**SEWAGE DISPOSAL SYSTEM**

**MARYLAND STATE DEPARTMENT OF HEALTH**

SUBDIVISION Talbot's Last Shift ROAD 5269 Talbots Landing LOT 9D

PROPERTY OWNER Charles Phillips

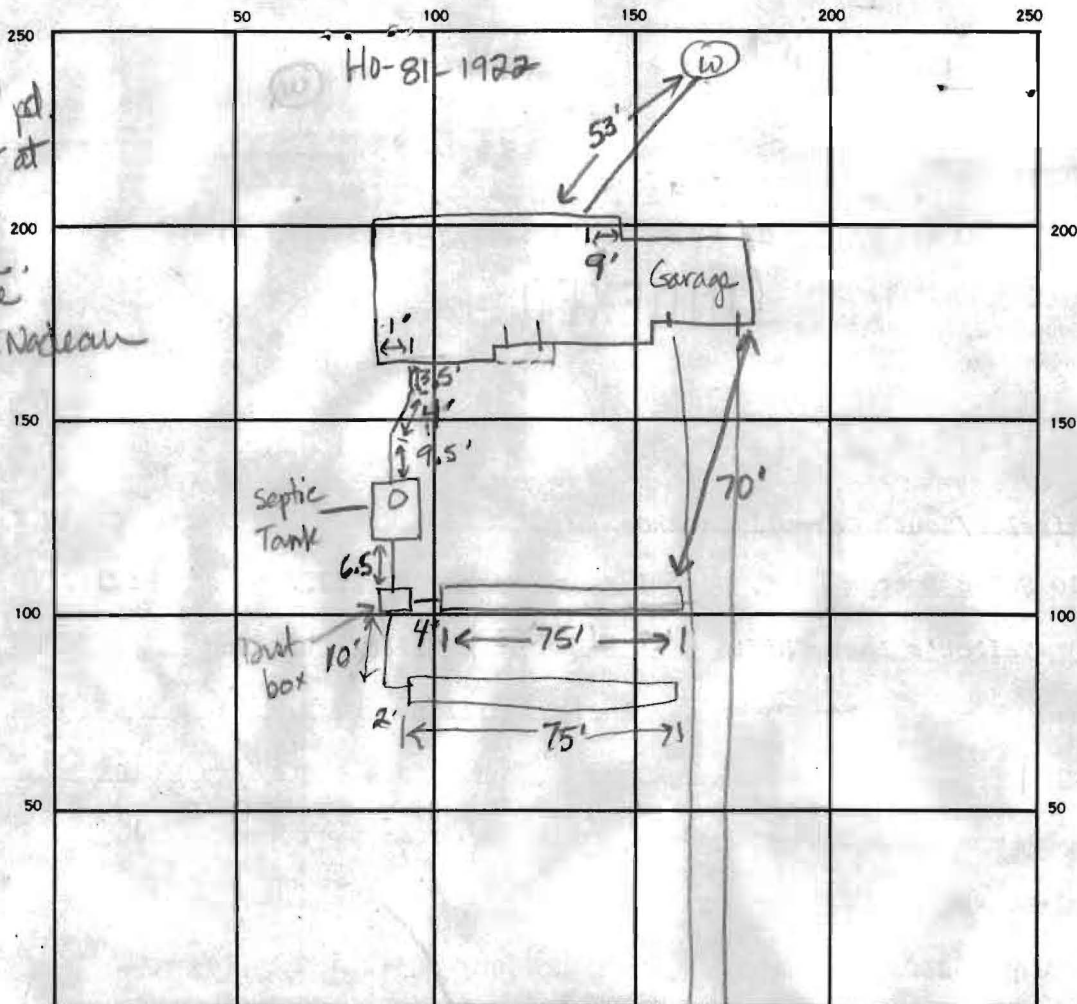
11-25-87  
 WP I - no \$ pd.  
 Pitless adaptor at  
 42 in. House  
 connection ok.  
 Ground line  
 on well. JENadeau

SEPTIC TANK, LEVEL \_\_\_\_\_ CLEANOUTS 1 on septic tank @ 3 ft depth  
 DISTRIBUTION BOX, LEVEL OK - remove clay & sand from floor of box  
 DRAIN FIELD/TILE FIELD, DEPTH 1.5 FT. TRENCH WIDTH 2 FT. INLET DEPTH 3.5 FT.  
 EFFECTIVE GRAVEL DEPTH 4 FT. TOTAL LENGTH 75' FT.  
 NUMBER OF TRENCHES 2 ONE SIDEWALL/BOTTOM AREA 300 SQ. FT.  
 DRYWELL INSIDE DIAMETER \_\_\_\_\_ FT. EFFECTIVE DEPTH BELOW INLET \_\_\_\_\_ FT.  
 ABSORBENT AREA 600 SQ. FT.

REMARKS 11-25-87 OK to add stone, pipe & paper to trench #1. OK to cover house to distribution box JEN. 11-27-87 OK to cover trench #1, add stone, pipe & paper to trench #2. OK to cover trench #2 and all other work. JEN

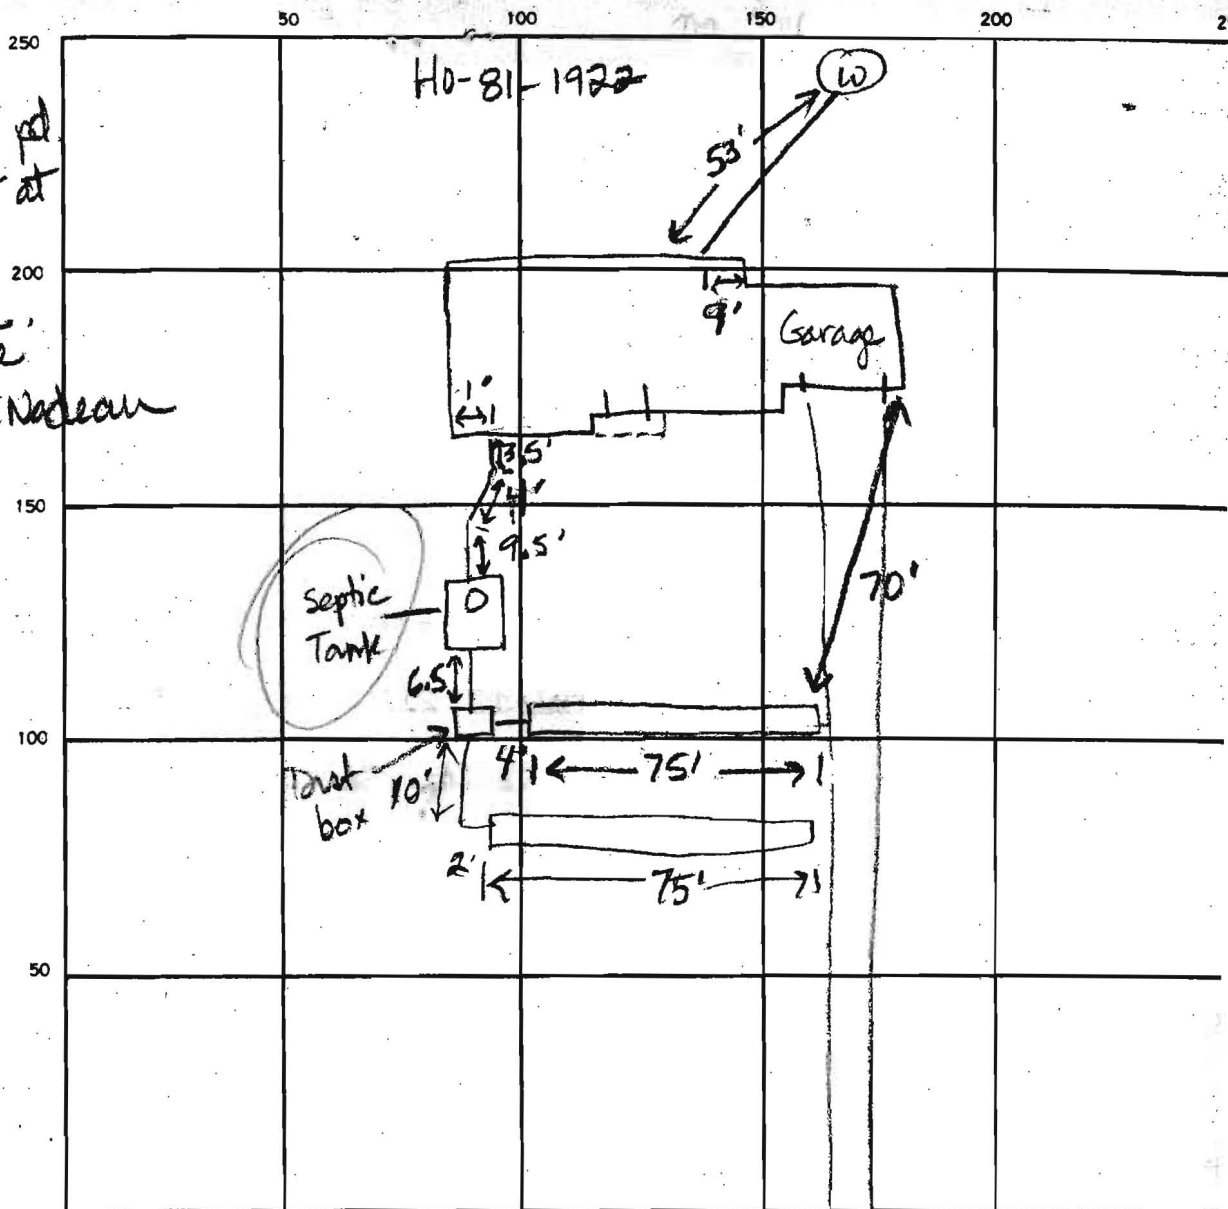
11-25-87  
 WP I - no #  
 Pitless adaptor at  
 42 in. House  
 connection ok.  
 Ground line  
 on well. JENadeau

SEPTIC TANK, LEVEL \_\_\_\_\_ CLEANOUTS 1 on septic tank  
 DISTRIBUTION BOX, LEVEL OK - remove clay & sand from floor of bc  
 DRAIN FIELD/TILE FIELD, DEPTH 1.5 FT. TRENCH WIDTH 2 FT. INLET DEPTH 3.5 FT.  
 EFFECTIVE GRAVEL DEPTH 4 FT. TOTAL LENGTH 75' FT.  
 NUMBER OF TRENCHES 2 ONE SIDEWALL/BOTTOM AREA 300 SQ.  
 DRYWELL INSIDE DIAMETER \_\_\_\_\_ FT. EFFECTIVE DEPTH BELOW INLET \_\_\_\_\_ FT.  
 ABSORBENT AREA 600 SQ. FT.

REMARKS 11-25-87 OK to add stone, pipe & paper to trench  
to cover house to distribution box JEN. 11-27-8
